PROJECT 2026-011825-HDRB. 619 W. Alameda St. Westside-Guadalupe Historic District. Contributing.
DESC: Dura Build Construction, agent for Max Scott, owner, proposes to install a bond beam, repair historic windows, re-roof the existing residence, and construct 40” high yard walls. An exception is requested to section 14-4.6(E)(2)(IV)(b) to raise the height of a contributing structure.

memo

DATE: March 24, 2026

2026-011825-HDRB. 619 W. Alameda St. Westside-Guadalupe Historic District. Contributing. Dura Build Construction, agent for Max Scott, owner, proposes to install a bond beam, repair historic windows, re-roof the existing residence, and construct 40" high yard walls. An exception is requested to section 14-4.6(E)(2)(IV)(b) to raise the height of a contributing structure.

west elevation
proposed elevations

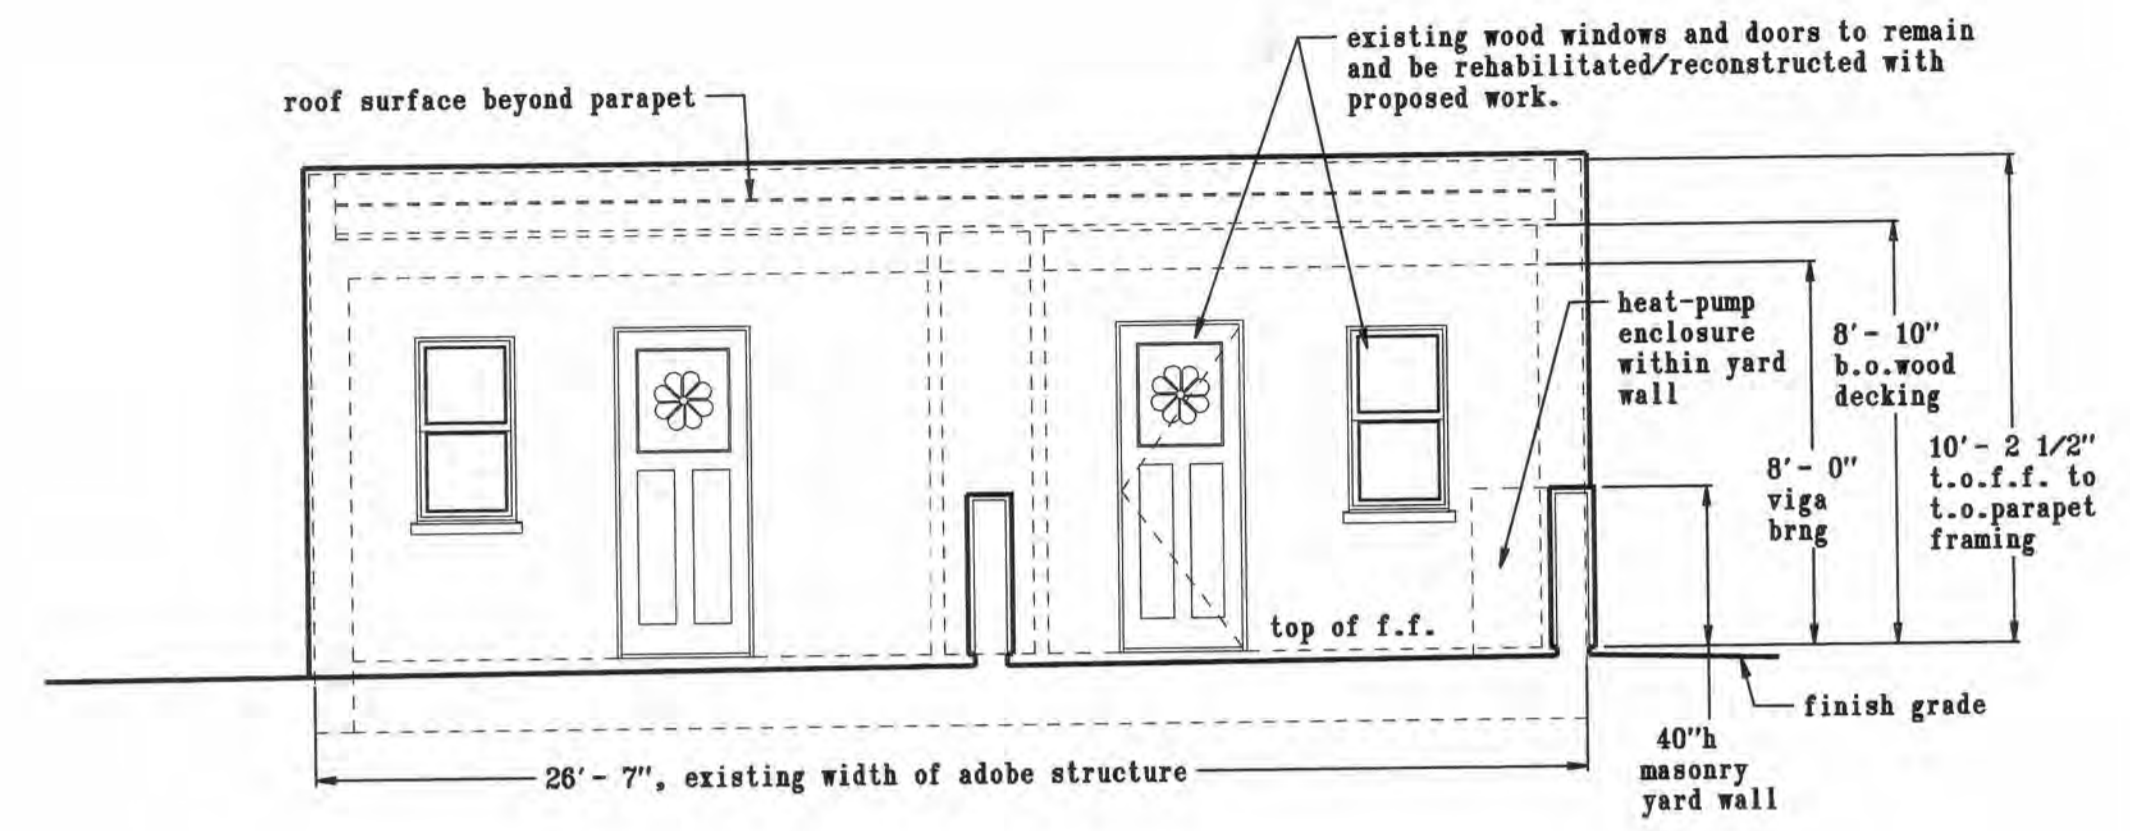
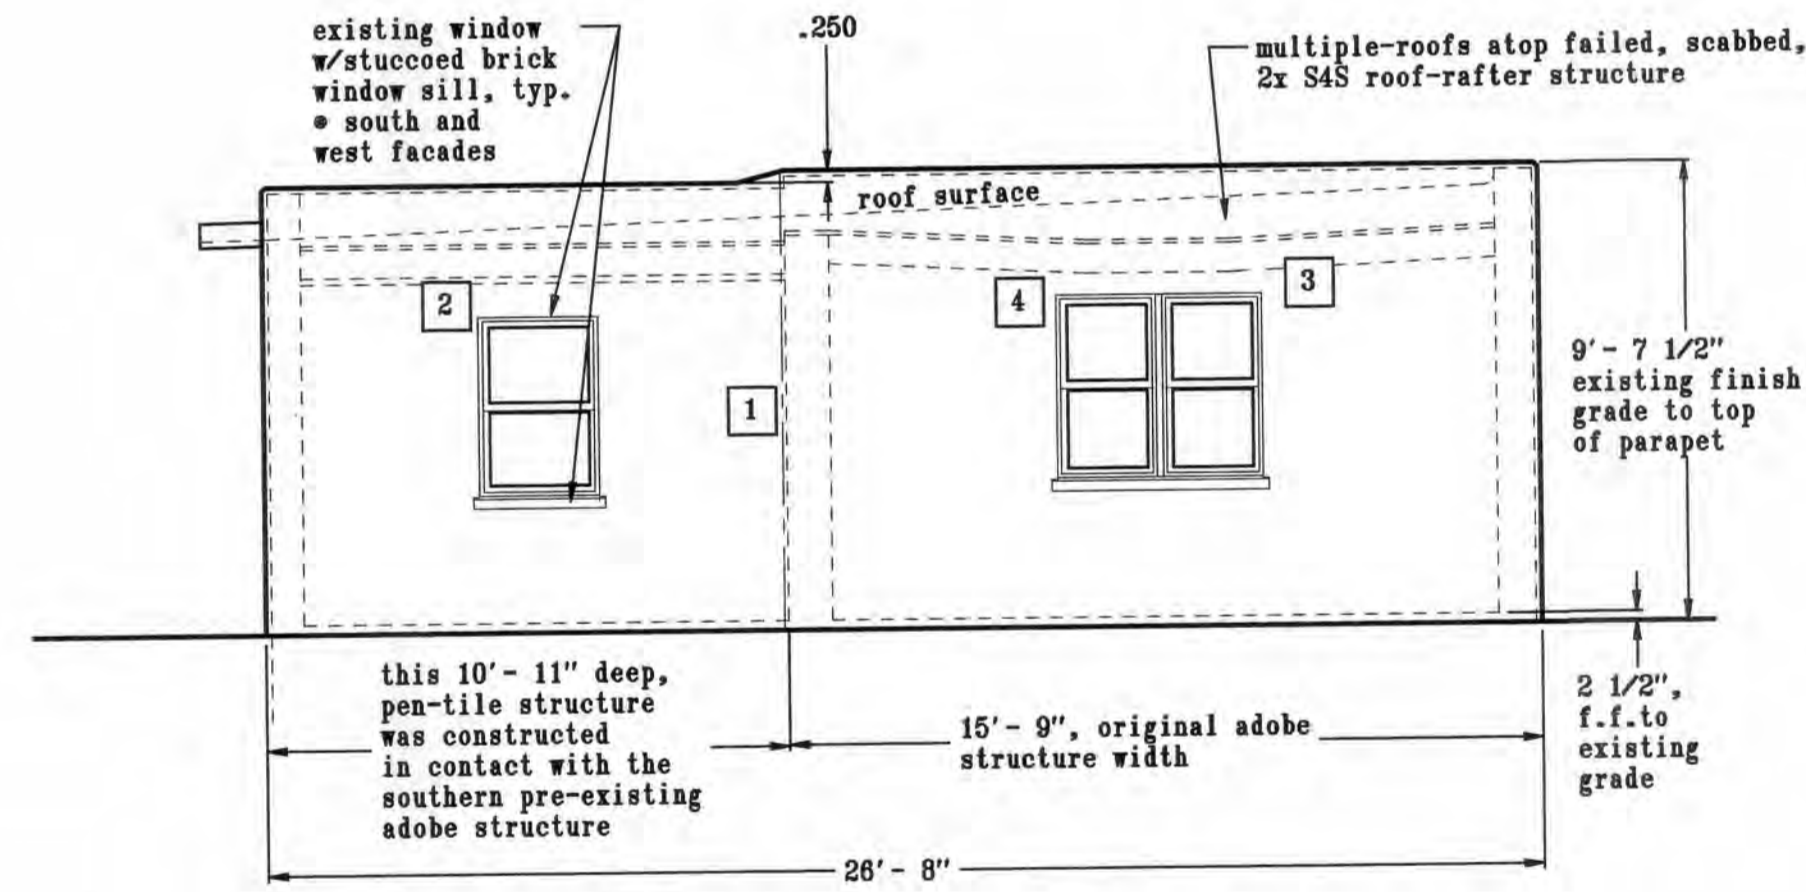
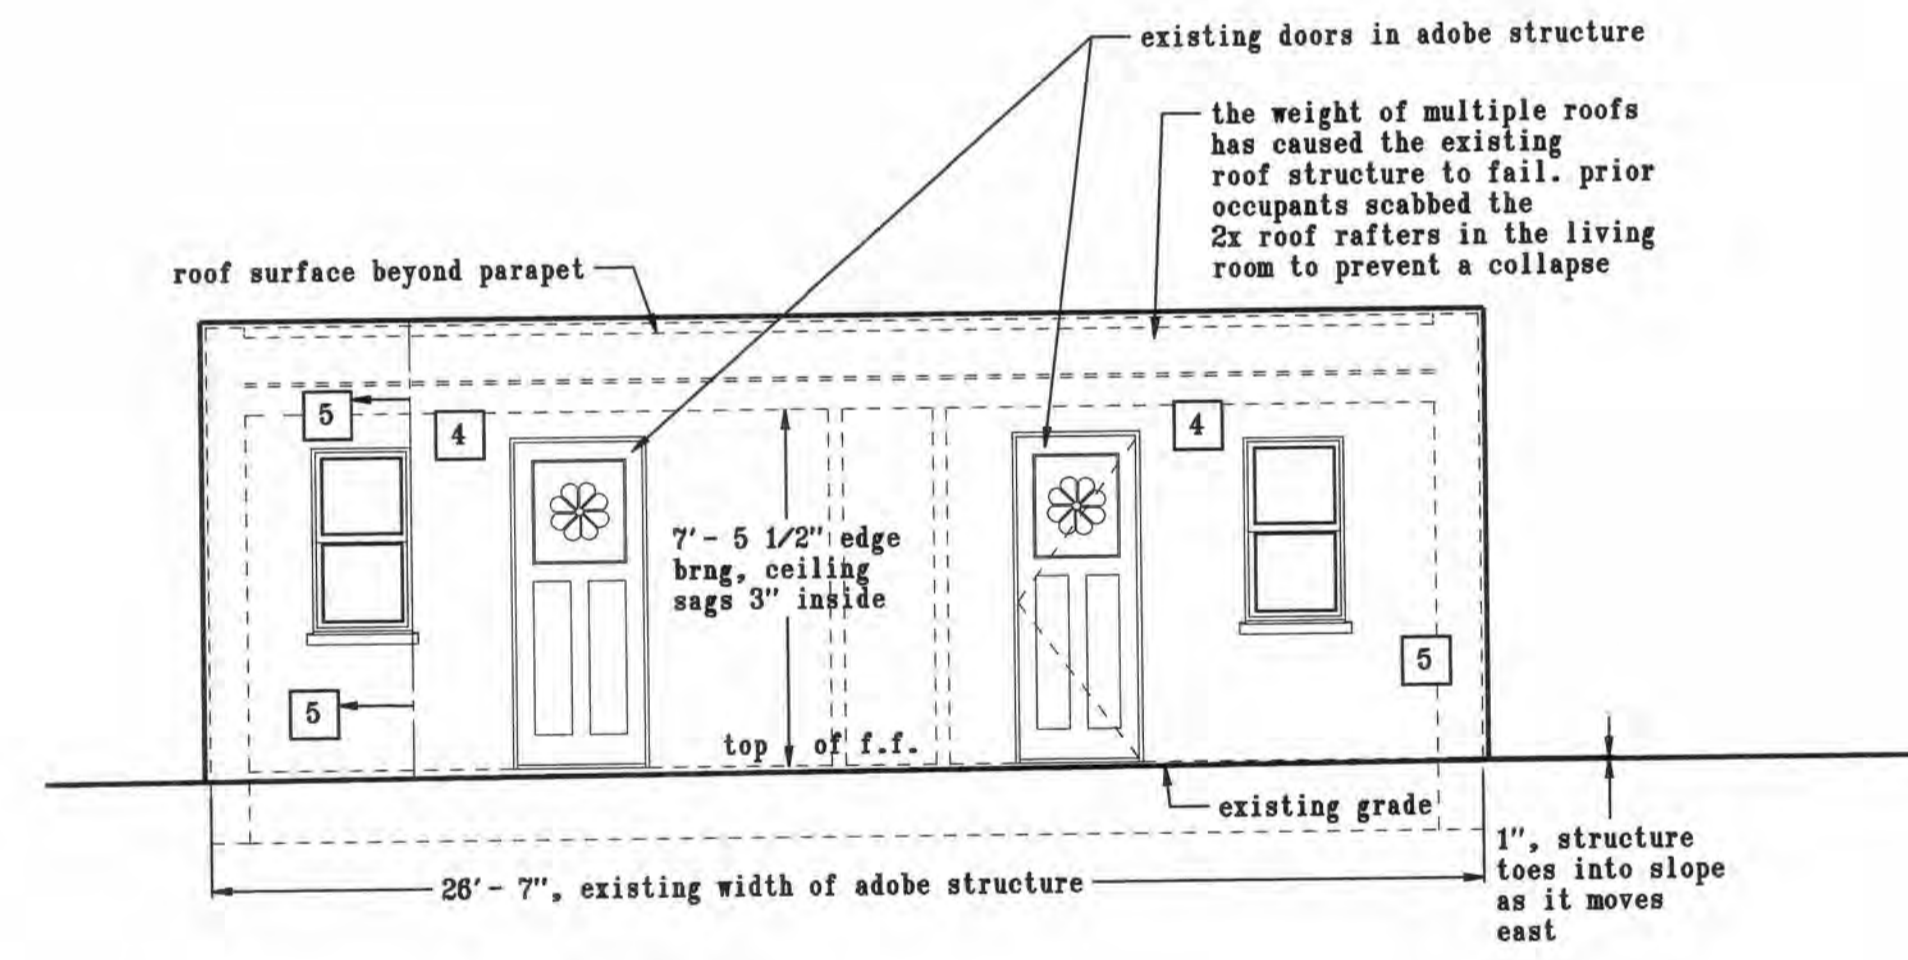
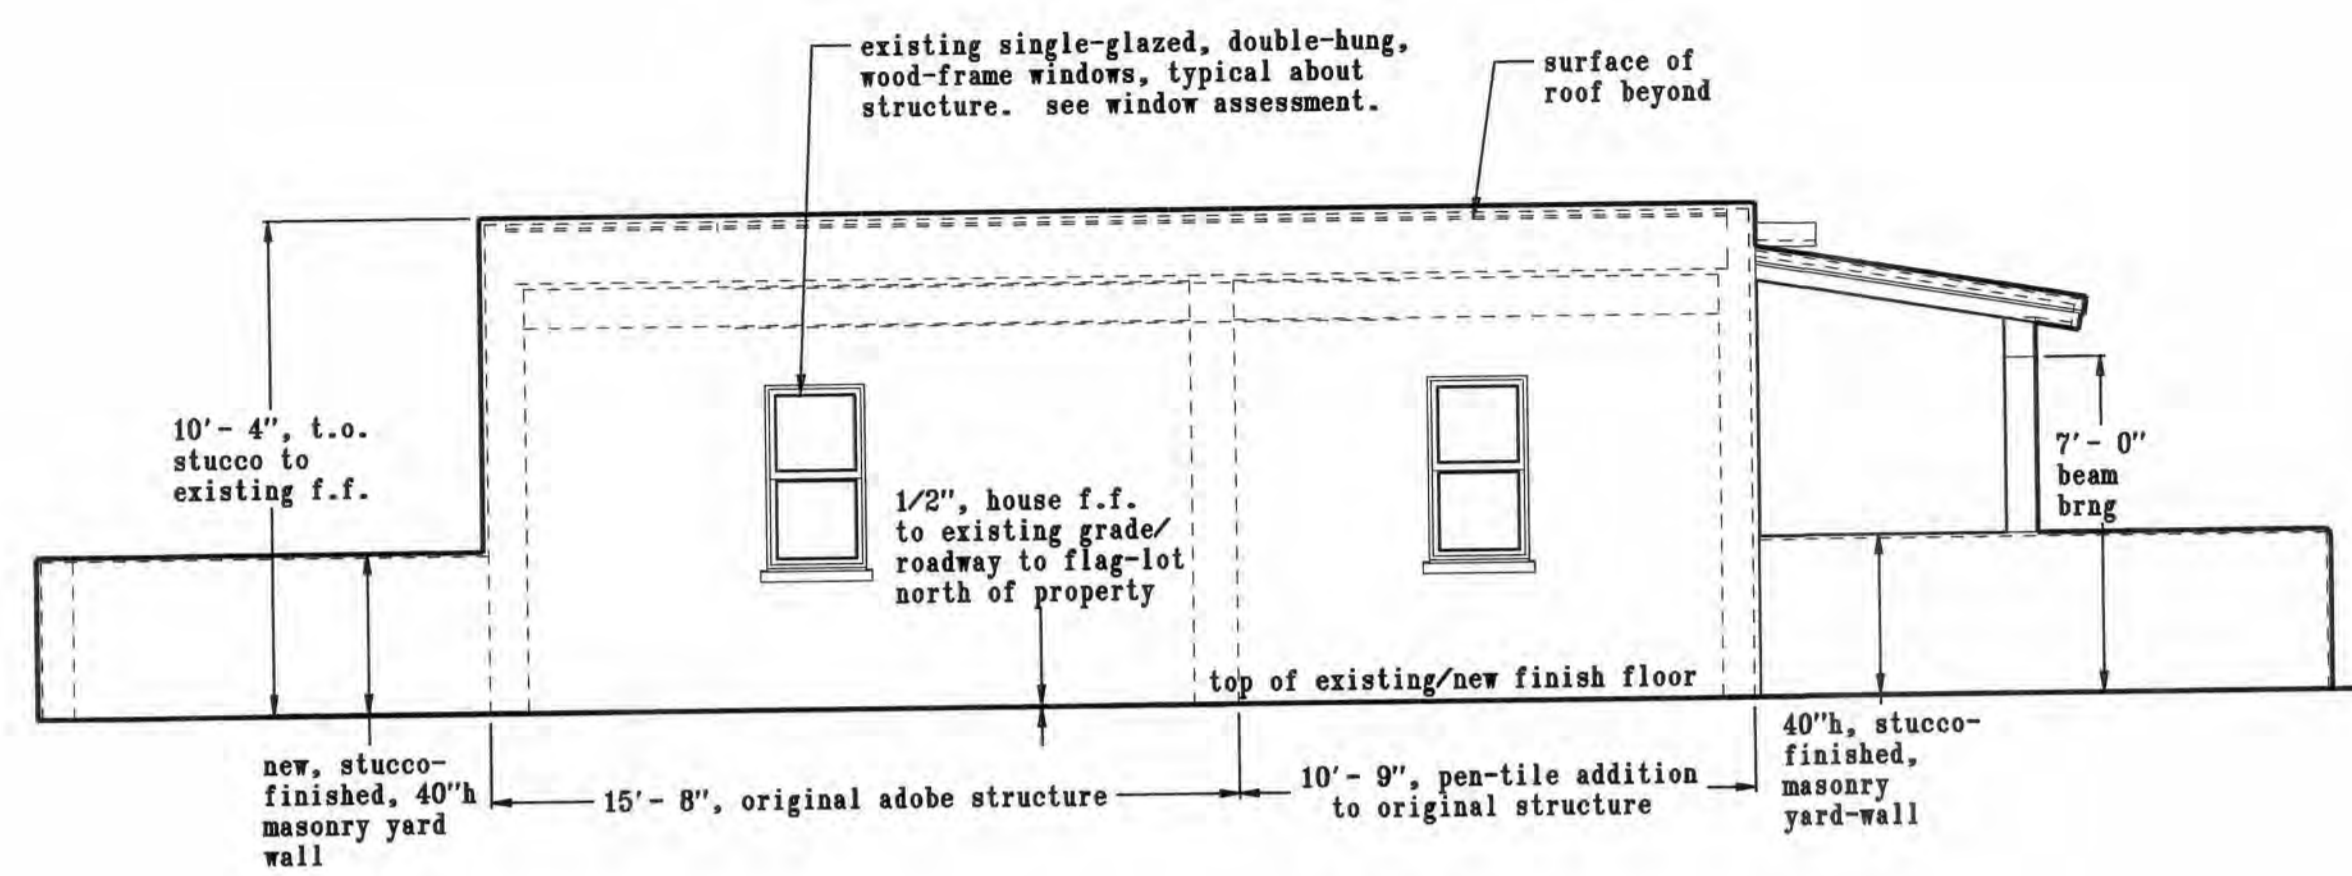
Exception to section 14-4.6(E)(2)(IV)(b): The applicant requests an exception to increase the height of a contributing structure.

Applicant Response: The historic structure, Unit A in our proposal, will remain well below Ms. McCulley's maximum height (14'-5"), but we do request a height change to this structure. Unit A's combination of adobe and pen-tile construction was built without a unifying bond beam atop the exterior walls. This has allowed horizontal movement at material joints and window and door rough openings, causing considerable cracking in the exterior walls. The original viga ceilings were removed at some point in the past and replaced with 2x roof rafters. These 2x rafters were undersized and failed under the weight of the roof years ago. The Dutchmen patches used to prevent roof collapse are not providing adequate structure and are also failing. Mesa Verde wishes to remove the existing roof and place a stabilizing concrete bond beam atop the existing exterior wall. The bond beam will prevent further horizontal movement in the building's cracks and unify the adobe and pen tile structure thus preparing it for a new viga roof. The resulting change in roof construction will change the building's height from: 9' - 4" from existing grade to top of stucco-finished parapet walls, to: 10' - 6 1/2" from top of existing grade to top of stucco-finished parapet walls. This increase in height will not affect the character of this historic structure or streetscape. It keeps the parapet at minimum height and secures the preservation of the existing structure for the foreseeable future.

Applicant Response: The resulting change in roof construction will change the building's height from: 9'- 4" from existing grade to top of stucco-finished parapet walls, to: 10'- 6 1/2" from top of existing grade to top of stucco-finished parapet walls while preserving the overall appearance of the unit.

Staff Response: Staff find that this criterion is met. The height change is minimal, and the structure will have the same appearance but a bond beam will prevent further deterioration of the structure therefore, the character of the district will not be damaged.

Staff Response: Staff find that this criterion is met. The approximately one-foot change in height is minimal and since the overall structure appearance is not changing, the impact of the change is the least negative impact.
